**MONITORING YEAR 1
ANNUAL REPORT**
Final

BUG HEADWATERS MITIGATION SITE

Subject: MY1 Report Review
Bug Headwaters Mitigation Site, Wilkes County
Yadkin River Basin: 03040101
DMS Project ID No. 100084
DEQ Contract #7617

As-Built IRT Comments

Wilkes County, NC

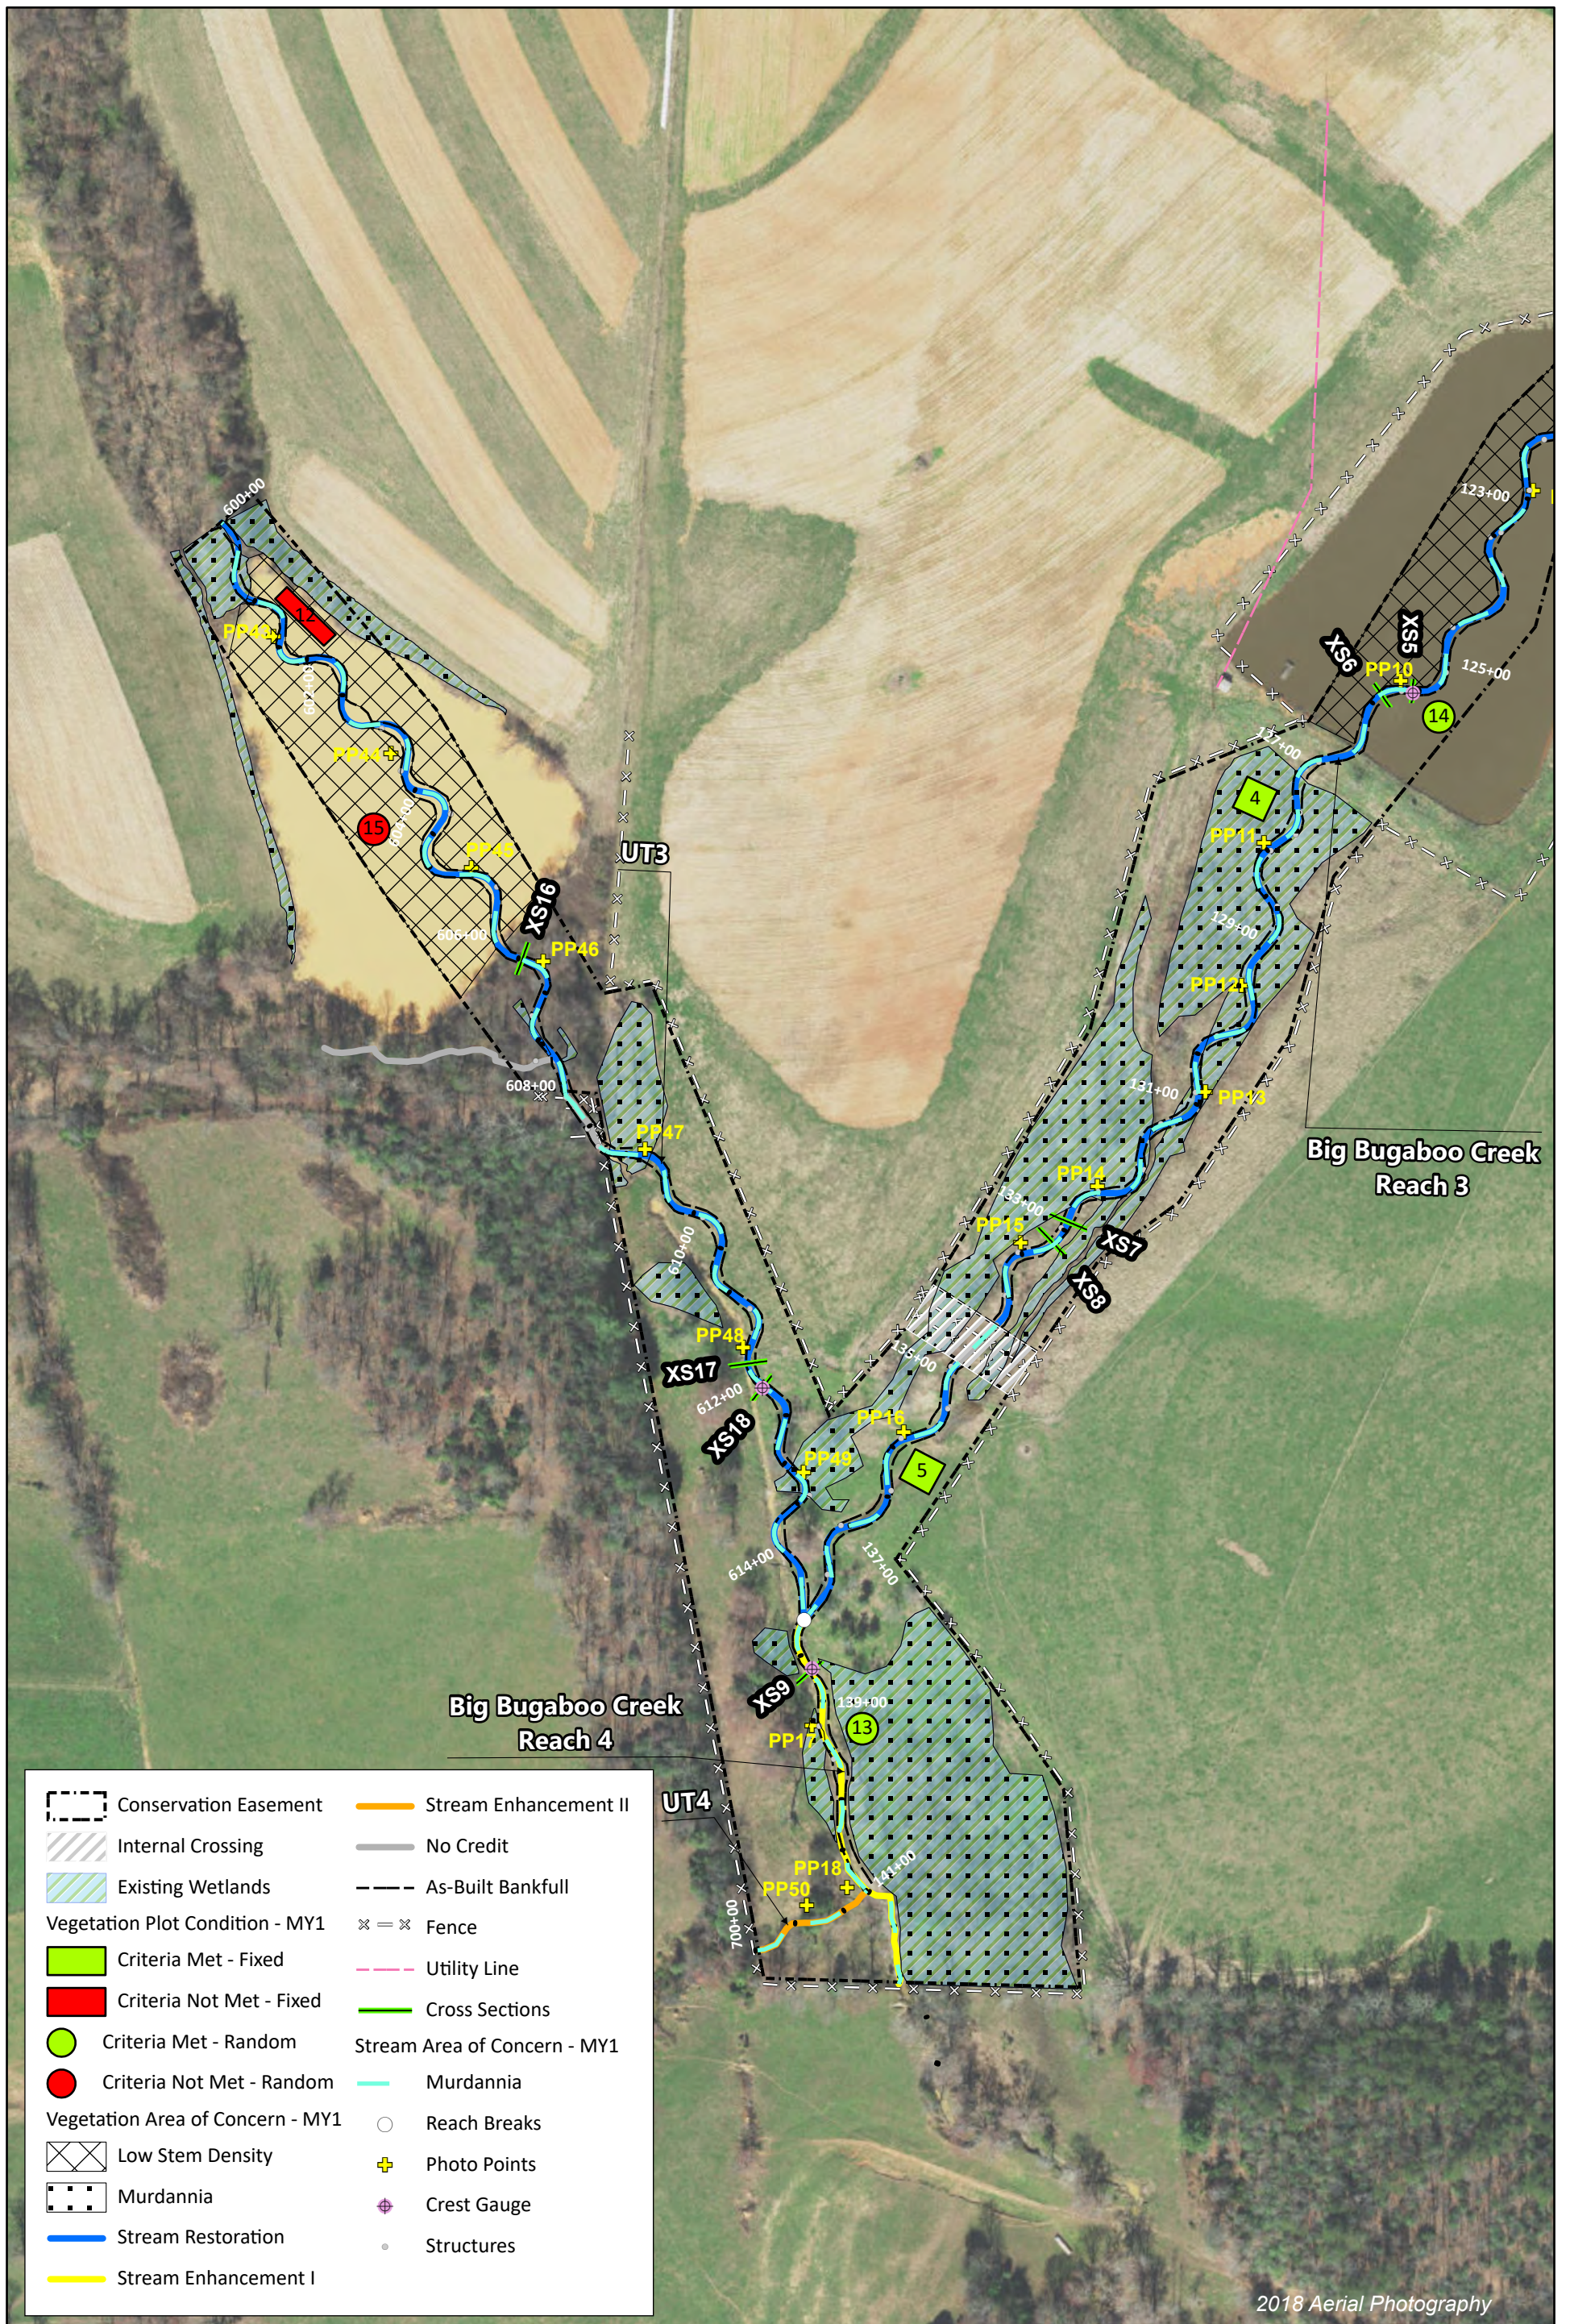
Murdannia is widespread on the site. All stream channels and wetlands are affected. DMS recommends discussing this problem with the IRT and developing an Adaptive Management Plan for this issue. This invasive species is aggressive and difficult to control and will likely be an ongoing issue throughout monitoring.

The MY1 assessment indicated only a small number of planted trees survived in the old pond bottoms along the right side of Big Bugaboo Creek Reach 3 and both sides of UT3 (Figure 1b-c). The visual assessment of the right side of Big Bugaboo Creek Reach 3 indicated some planted trees survived, but

Response: The IRT has been notified, and correspondence is located in Appendix F.

Supplemental planting will occur in the former pond bottoms along the right side of Big Bugaboo Creek Reach 3 and both sides of UT3. Due to saturated soil conditions, a mixture of bare roots and live stakes will be planted in the winter of 2022. While species selection will be dependent on nursery availability, the current plan includes black willow (*Salix nigra*), silky willow (*Salix sericea*), elderberry (*Sambucus spp.*), and button bush (*Cephalanthus occidentalis*) as live stakes and sycamore (*Platanus occidentalis*),
